Answers to Selected EXQ1 Questions

East Pye Solar PINS Reference: EN0110014

Submitted by BEPS (Block East Pye Solar F816760F0)

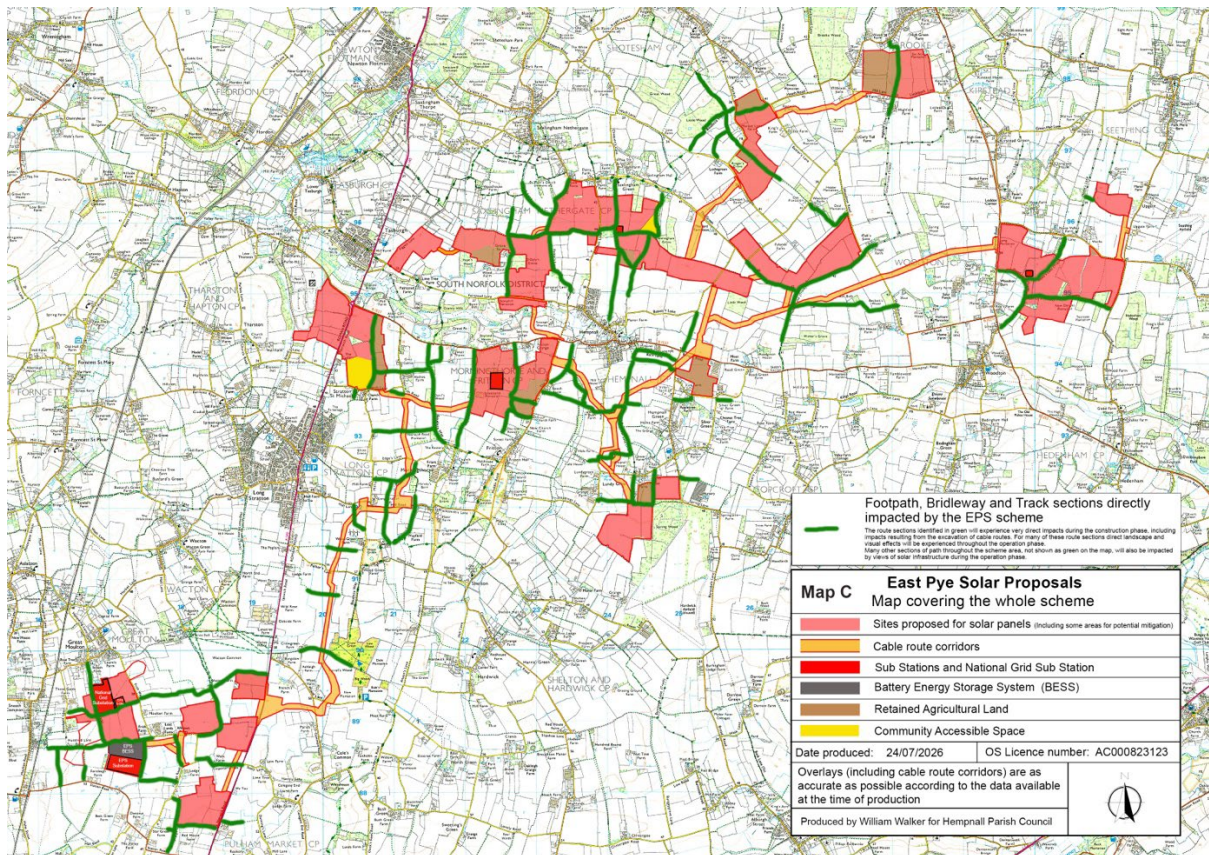
The Applicant's current reliance on a nominal 15 m stand-off from each side of a PRoW does not answer the point. At ISH1, after BEPS raised these concerns, the ExA asked whether the proposed fencing arrangements had been subject to a road-safety audit. The Applicant stated that, so far as it was aware, they had not, and instead referred to the 15 m offsets which could produce a 30 m-wide corridor where solar lies on both sides. Width alone does not establish that such a corridor is safe or acceptable. The experience of a route will depend upon the combined effect of:

- whether arrays and fencing occur on one or both sides;
- whether the other side is also enclosed by a high hedge or woodland;
- the height and character of the fencing;
- whether planting subsequently creates additional enclosure;
- forward and lateral visibility;
- the number and location of exits and junctions;
- surveillance and the ability to see or be seen from nearby roads, houses or open land;
- CCTV and lighting infrastructure;
- the position of conversion units, switchrooms and other structures;
- the length for which the enclosed condition persists;
- and the way the route is actually used, including by women walking alone, children, older people and others for whom perceived safety may materially determine whether the route remains usable.
